SUNDRY NOTICES AND REPORTS ON WELLS

8. FARM OR LEASE NAME  
Ruben Canyon

Request for (other) Approval to change access road

Vicinity Map for  
 SOUTHLAND ROYALTY COMPANY  
 RUBEN CANYON #1  
 1730' FNL & 940' FWL  
 Section 35, T30N, R4W  
 Rio Arriba County, New Mexico

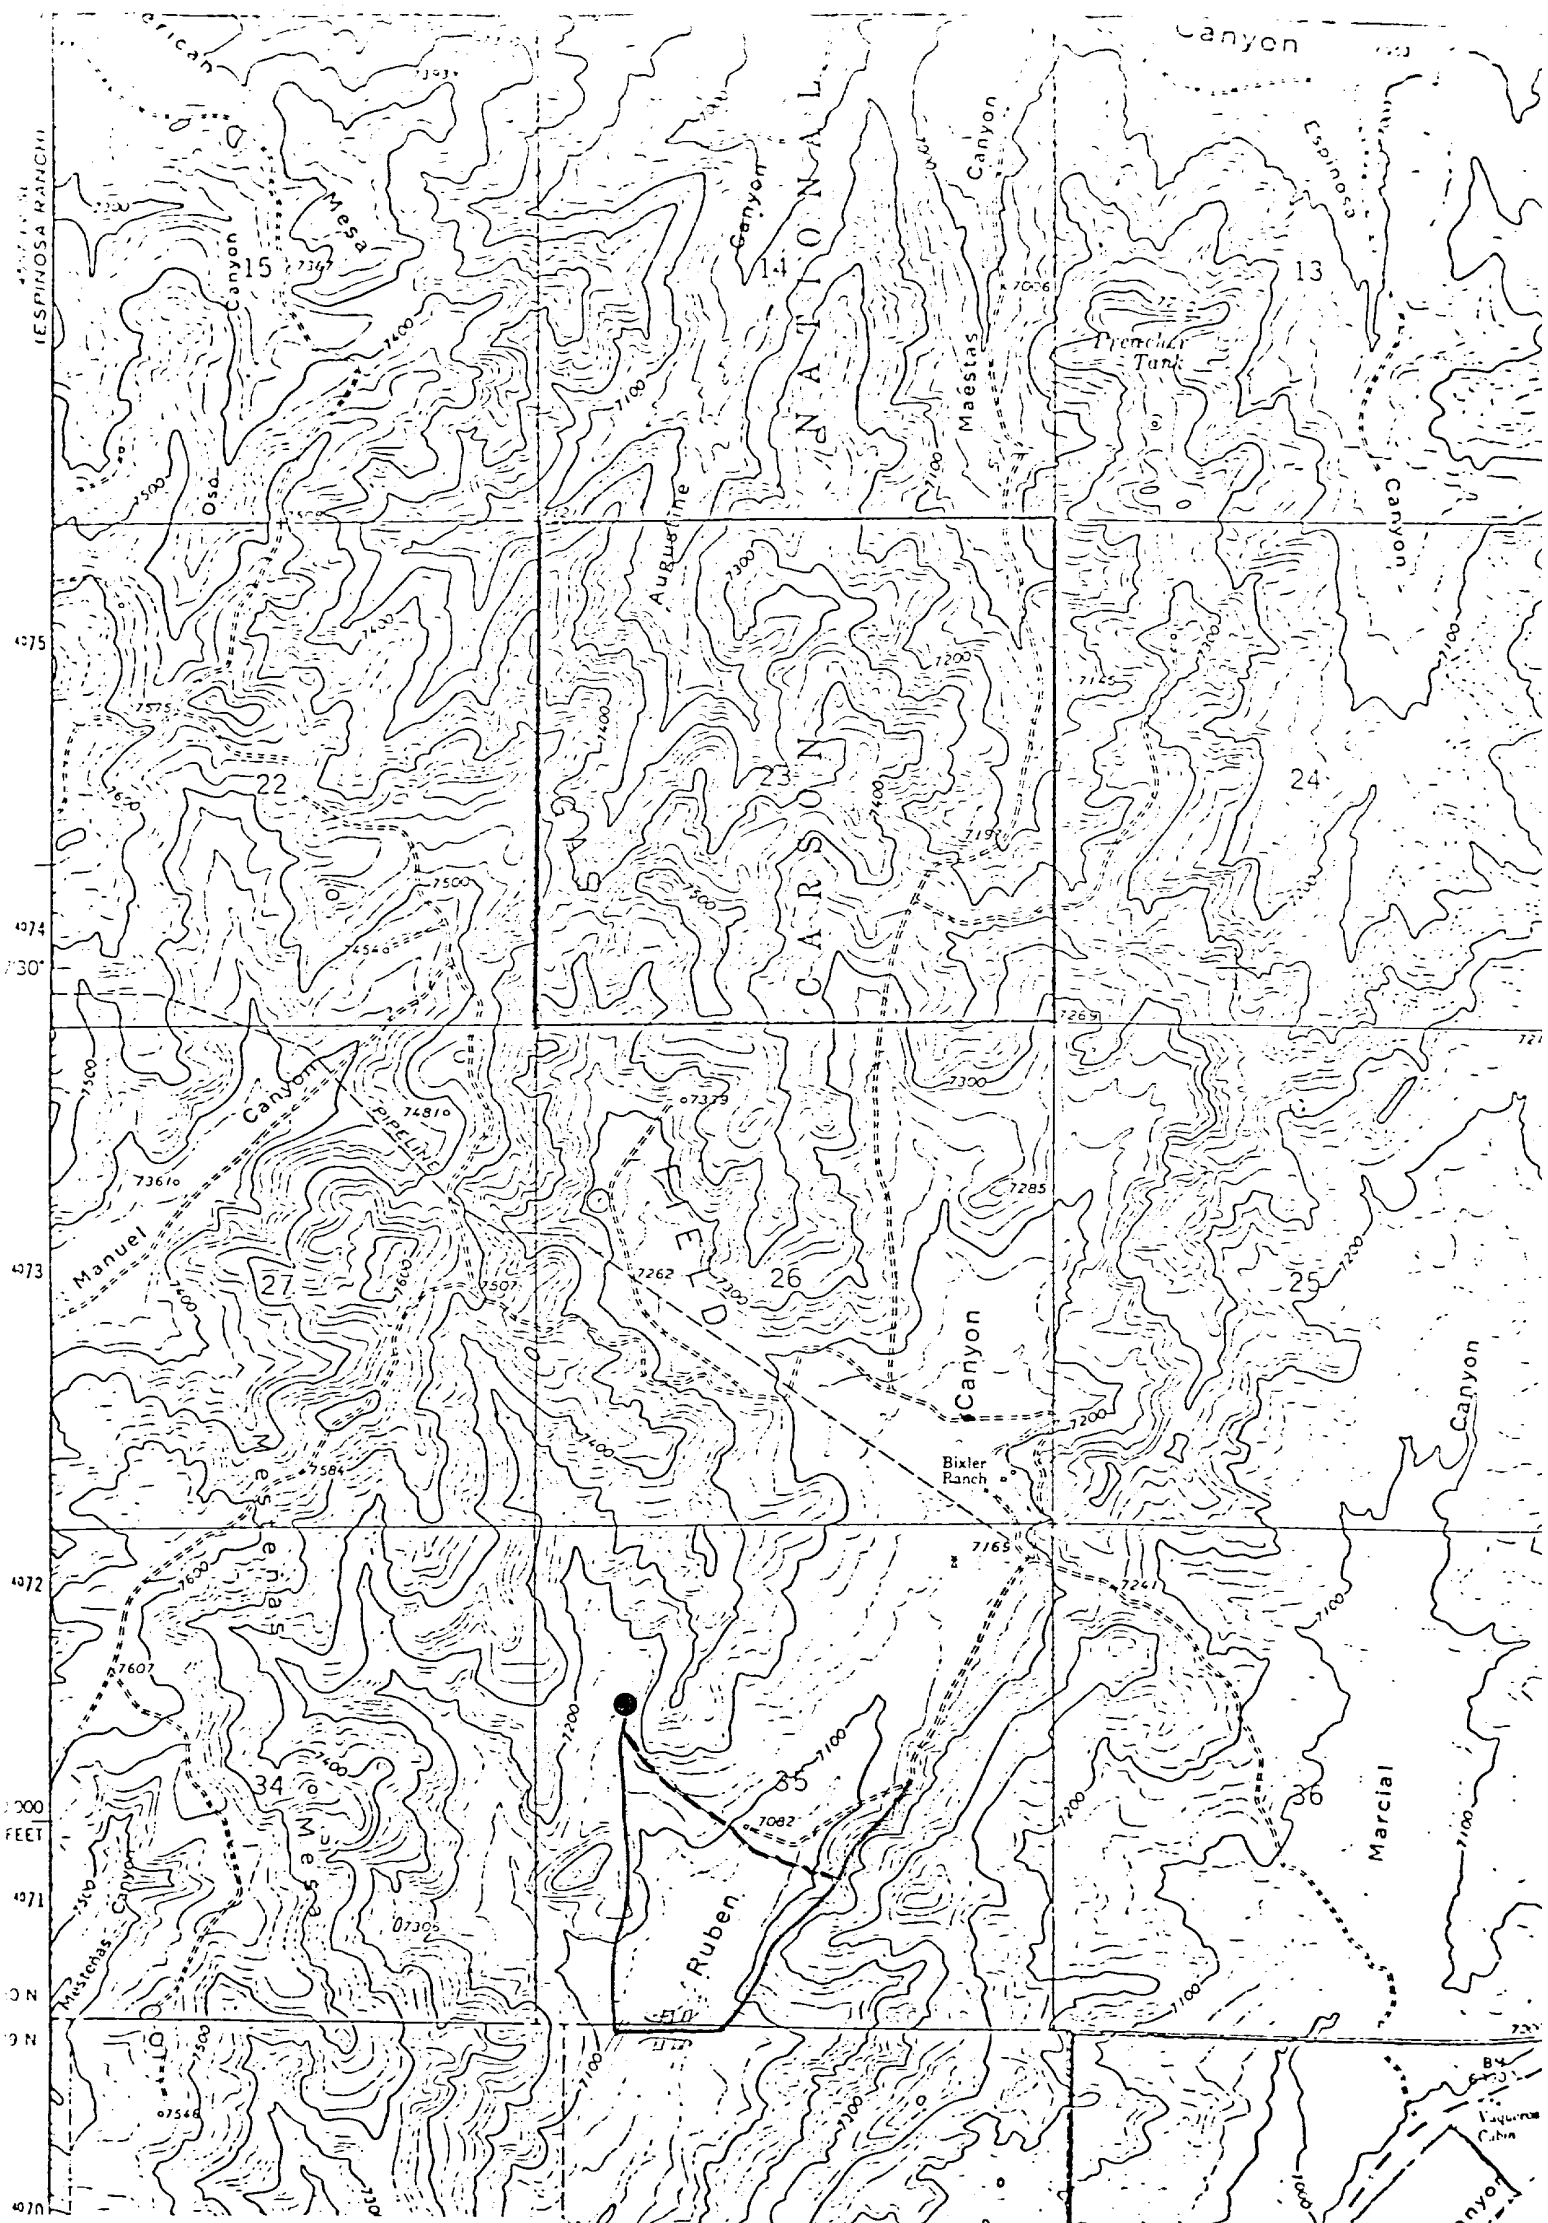
10/27/81 SOUTHLAND ROYALTY COMPANY proposes to change access road to the subject location. Proposed re-route is shown on the attached topographic quadrangle. Re-route is necessitated by refusal of fee surface landowner to grant access through his property.
